REVISION SUMMARY

Section	Changes	Reason for Change
Part 2: Final Safety Analysis Report		
Tables 2.0-202 & 2.2-203	Revised table data, added % Difference column, deleted note (c)	EPRI 2013 GMM is current source for values
Figures 2.0-201 thru 2.0-204, 2.0-206, 2.0-207, 2.5.2-230 thru 2.5.2-258, 2.5.2-274 thru 2.5.2-320	Revised	EPRI 2013 GMM is current source for values

2.5.2.1.1.1.2, 2.5.2.2.4.3, 2.5.2.4.1, 2.5.2.4.5.1, 2.5.2.6.2	Changed reference from EPRI 2004 to EPRI 2013	EPRI 2013 GMM is current source
2.5.2.4.4	Revised to account for EPRI 2013	EPRI 2013 GMM is current source

NAPS COL 2.0-27-A **Figure 2.5.2-311 Horizontal and Vertical PBSRS for RB/FB and CB**

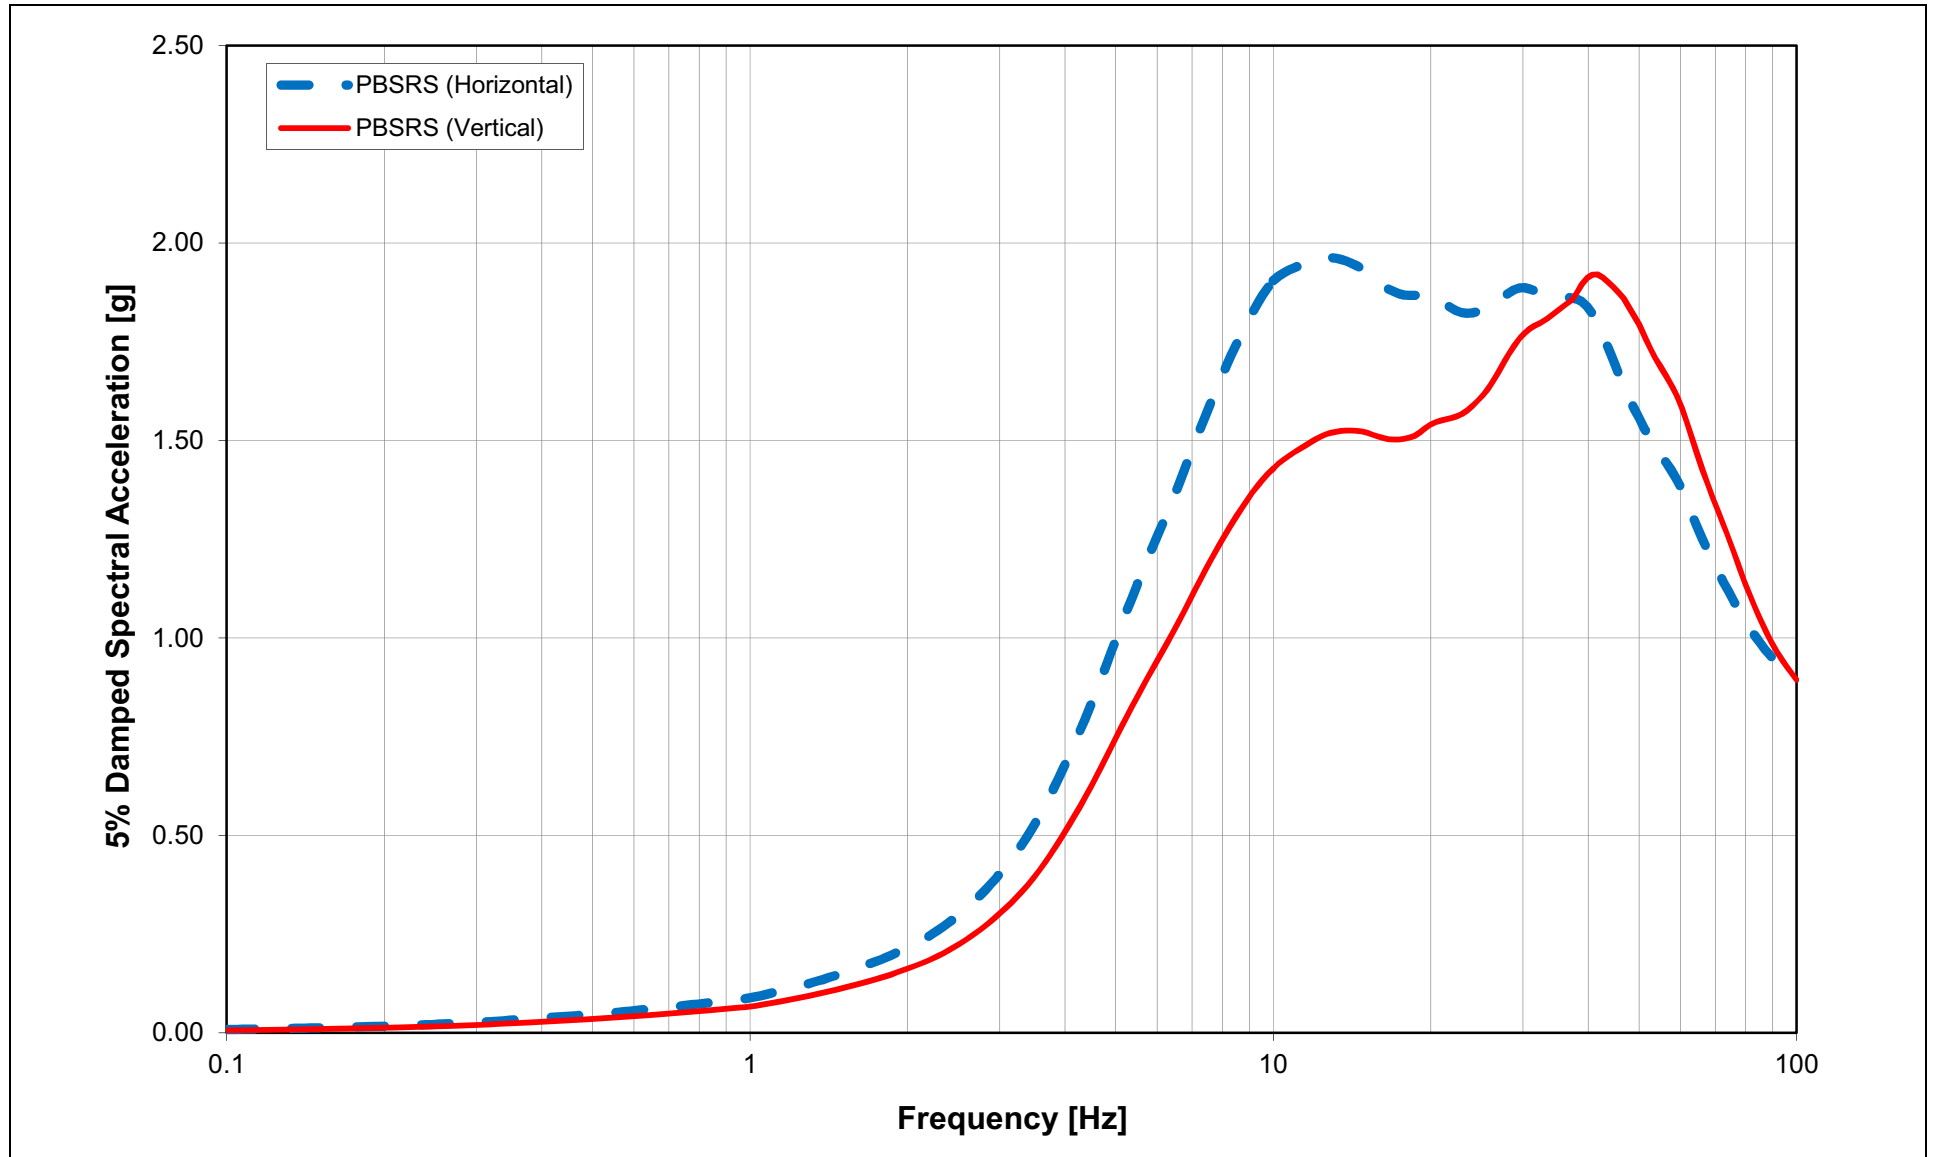
Upon application of Equation 2.5.2.6-4, the V/H ratio and corresponding $\text{PBSRS}_V(f)$ for the PBSRS for CB/FB and CB are tabulated in Table 2.5.2-226 and the $\text{PBSRS}_V(f)$ is shown in Figure 2.5.2-311.

NAPS COL 2.0-27-A Figure 2.5.2-312 Horizontal and Vertical FWSC Geologic Outcrop FIRS
NAPS DEP 3.7-1

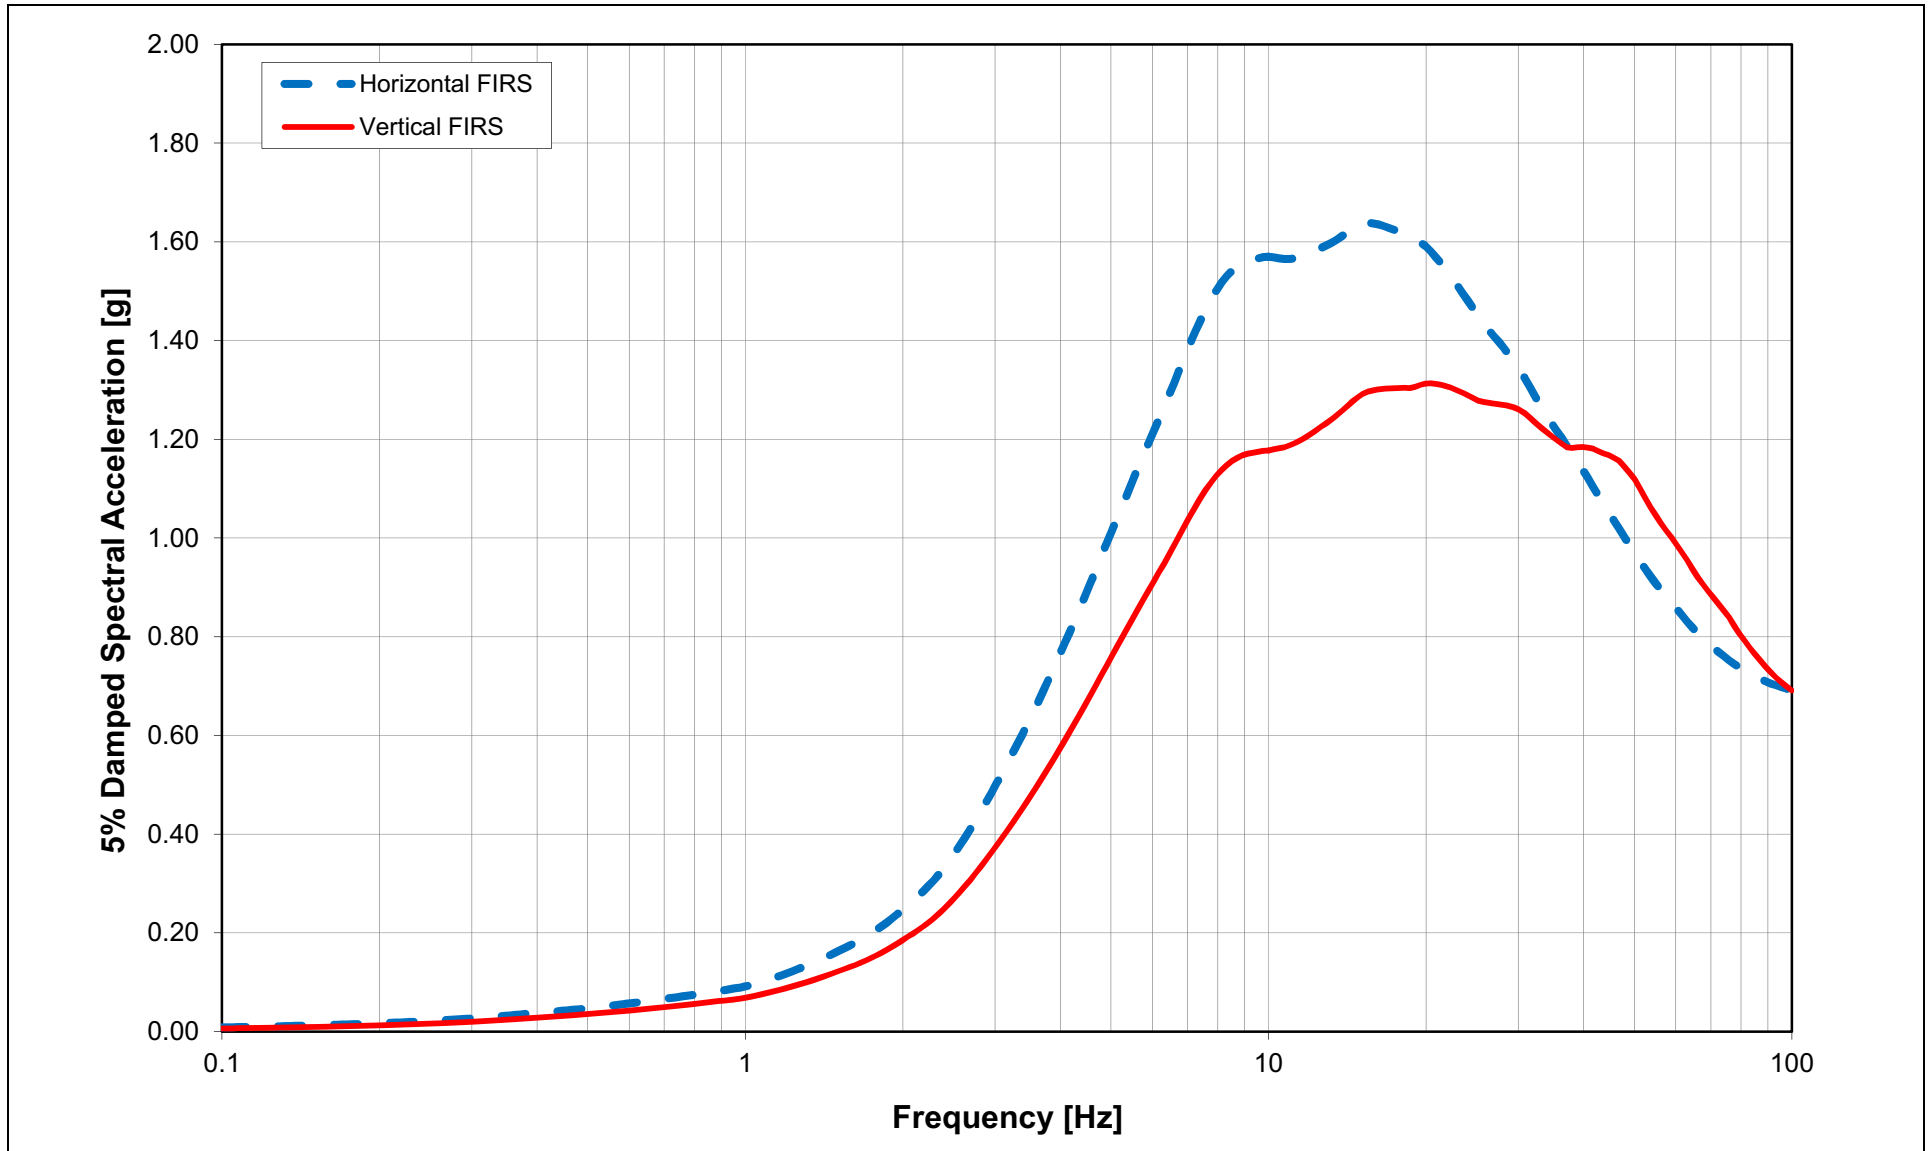
Figure 2.5.2-306 shows the plot of the $UHR_{SH}(f|10^{-4})$ and $UHR_{SH}(f|10^{-5})$ for the FWSC geologic outcrop at the elevation of 282 ft. The same figure shows the corresponding DRS, as developed in application of Equations 2.5.2.6-1 through 2.5.2.6-3. This DRS is the FWSC Geologic Outcrop Horizontal FIRS, as shown in Figure 2.5.2-312 and tabulated in Table 2.5.2-227.

Upon application of [Equation 2.5.2.6-4](#), the V/H ratio and corresponding $FIRS_V(f)$ for the FWSC Geologic Outcrop are tabulated in [Table 2.5.2-227](#) and the $FIRS_V(f)$ is shown in [Figure 2.5.2-312](#).

NAPS COL 2.0-27-A Figure 2.5.2-313 Horizontal and Vertical GMRS
NAPS ESP VAR 2.0-4

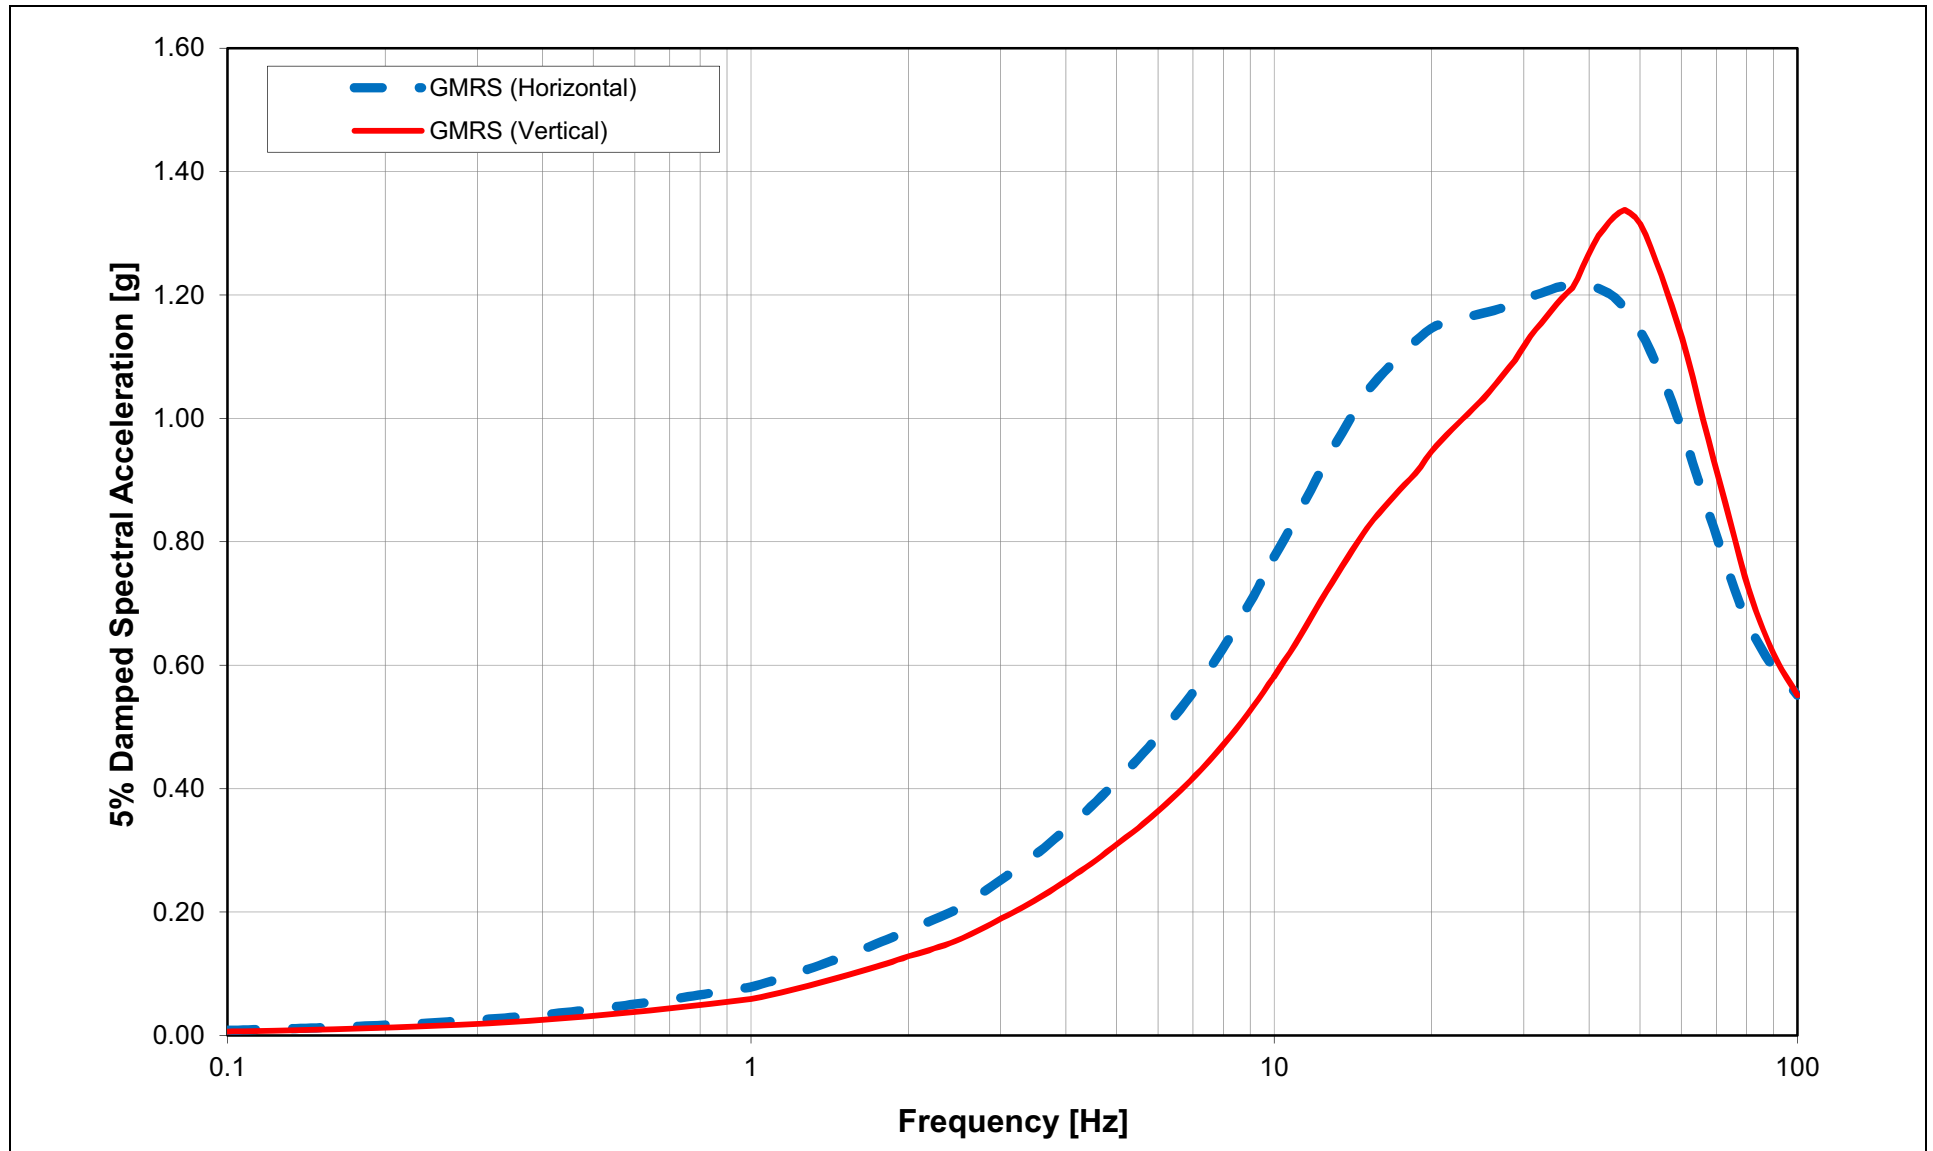
Given the proximity of the RB/FB and CB structures and consideration of marginal conservatism, the GMRS, as shown in Figure 2.5.2-313 and tabulated in Table 2.5.2-228, is the envelope of the two DRS shown in Figures 2.5.2-299 and 2.5.2-305.

NAPS COL 2.0-27-A **Figure 2.5.2-314** **Rock V/H Ratios Recommended in NUREG/CR-6728** ([Reference 2.5-385](#))
NAPS ESP VAR 2.0-4

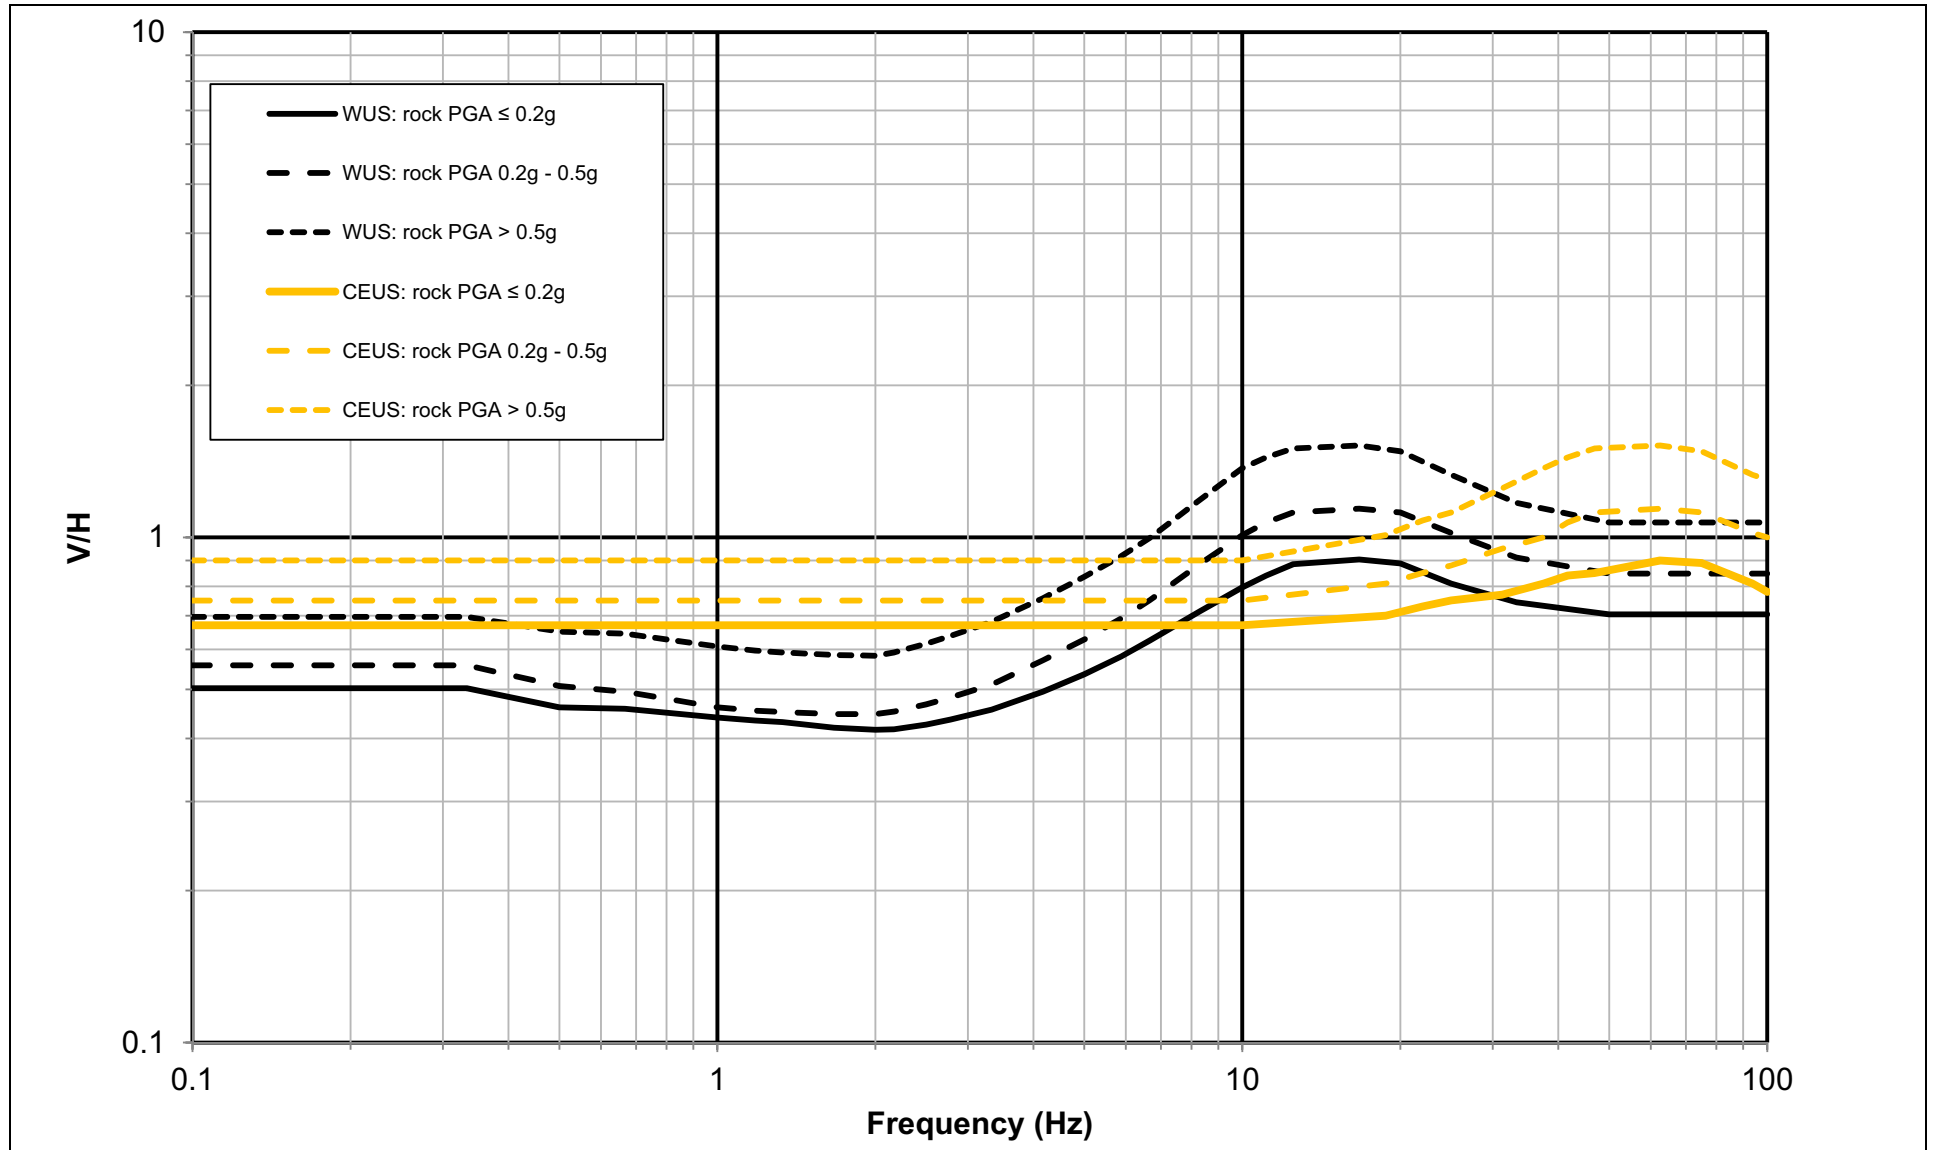
Figure 2.5.2-314 plots WUS rock and CEUS rock V/H ratios from the NUREG (Reference 2.5-385). The CEUS rock V/H from the NUREG gives the $V/H_{\text{CEUS,rock}}$ of Equation 2.5.2.6-5, as a function of the appropriate hard rock PGA. Given the hard rock PSHA results in Table 2.5.2-217, the 10^{-4} and 10^{-5} PGA values are ~~0.259g and 0.847g~~ 0.271g and 0.854g, respectively. Applying RG 1.208 DRS Equations 2.5.2.6-1 through 2.5.2.6-3, an equivalent hard rock DRS PGA would be ~~0.401g~~ 0.407g. Consequently, the appropriate NUREG CEUS rock V/H function, to be used as $V/H_{\text{CEUS,rock}}$, is the middle V/H ratio relationship, specified for $0.2\text{g} < \text{PGA} \leq 0.5\text{g}$.

One of the aspects of the GA11 model is that for V_{S30} greater than about 5,000 ft/s, the V/H ratio does not change. Therefore, for the RB/FB and CB columns at the elevations above $(V/H_{\text{WUS,soil}} / V/H_{\text{WUS,rock}})_{\text{frequency-shifted}}$ is simply unity, and the applicable V/H ratio $V/H_{\text{CEUS,soil}}$ is just equal to $V/H_{\text{CEUS,rock}}$, the middle CEUS hard rock V/H ratio relationship, specified for $0.2g < \text{PGA} \leq 0.5g$, given by the NUREG (Reference 2.5-385). See Figure 2.5.2-314.
